To: Richard Collier, McKim & Creed
From: Brian Chambers, Senior Planner; 910.342.2782
CC: File;
Date: 3/10/2022
Re: Riverlights MX 2A Townhomes TRC Rev 2

Project Name: Riverlights MX-2A Townhomes
Reviewer: Eric Seidel, PE
Department: Engineering – Plan Review Section

Project Name: **RIVERLIGHTS MX2A TOWN HOUSES**

Riverlights MX2A Townhomes Standard Street Lighting Plan

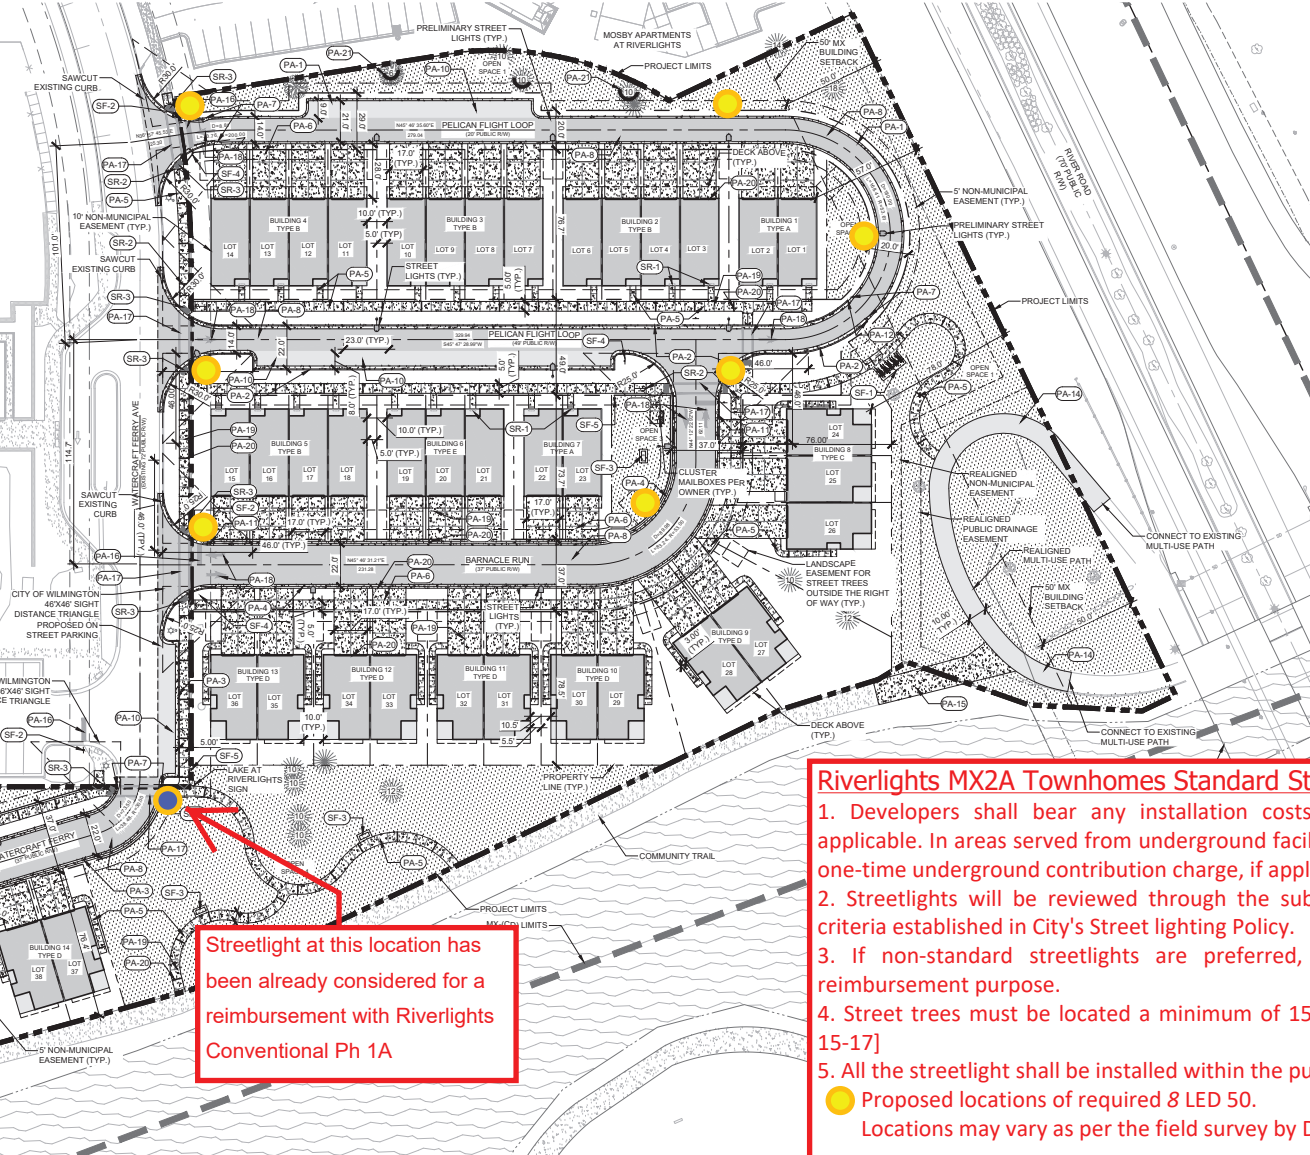
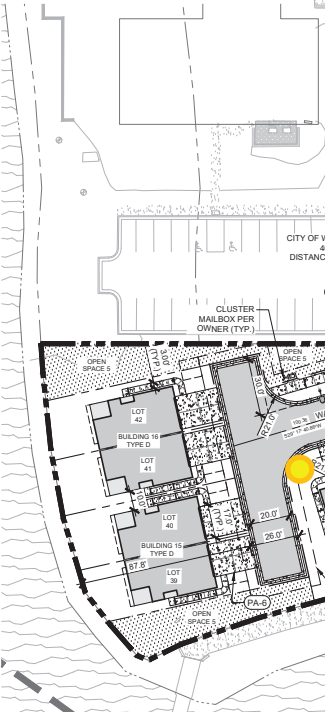
1. Show and callout all the existing streetlights on Watercraft Ferry Ave abutting this development. One existing streetlights near the on-street parking on Watercraft Ferry Ave is missing on the plans.

2. Coordinate with Duke Energy and provide the details for the type and number of streetlights proposed for this project on the plans.
3. Minimum one streetlight shall be installed at the end of Watercraft Ferry Ave turnaround in the vicinity between Lot 38 and 39.

5. A layout for the Standard Street lighting has been provided with the review. Minimum of 8 (eight) standard streetlights are required for this sub-division. This layout is subject to change based on the location of existing streetlight location and type of proposed streetlights for this project.

Streetlight at this location has been already considered for a reimbursement with Riverlights Conventional Ph 1A

1. Developers shall bear any installation costs associated with streetlights, if applicable. In areas served from underground facilities, the developers shall pay the one-time underground contribution charge, if applicable.
2. Streetlights will be reviewed through the subdivision process and must meet criteria established in City's Street lighting Policy.
3. If non-standard streetlights are preferred, this plan may be utilized for reimbursement purpose.
4. Street trees must be located a minimum of 15 feet from streetlights. [CofW SD 15-17]
5. All the streetlight shall be installed within the public ROW.
● Proposed locations of required 8 LED 50. Locations may vary as per the field survey by DEP.
